SUPPLEMENTAL BID BULLETIN NO. 1

**SUPPLY, DELIVERY, INSTALLATION AND TESTING OF VARIOUS SINGLE PASS RICE MILLS
 (PHilMech-RCEF-23-06-15)**

This **Supplemental/Bid Bulletin No. 1** is being issued to clarify, amend and supplement provisions in the Bidding Documents.

ANNEX A. RECOMMENDED BIN DIMENSION

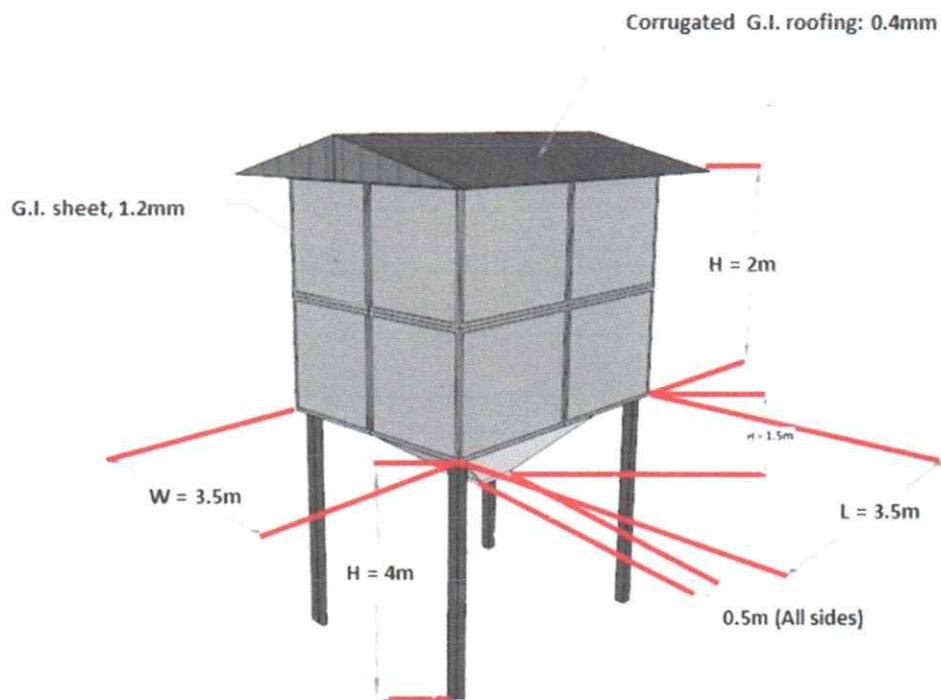
3. <i>Issue / Proposal: Inquiry if PHilMech has specific dimension for the rice hull bin because the 30 cu. meter capacity when converted would reach to 5 meters which is too high.</i>	
<i>Action Taken/Reply: Recommended bin dimension is hereby attached as Annex A.</i>

12. Issue / Proposal: Inquiry on the minimum required height from the ground up to the lowest point of the rice hull bin		
Action Taken/Reply: Please see attached Annex A.
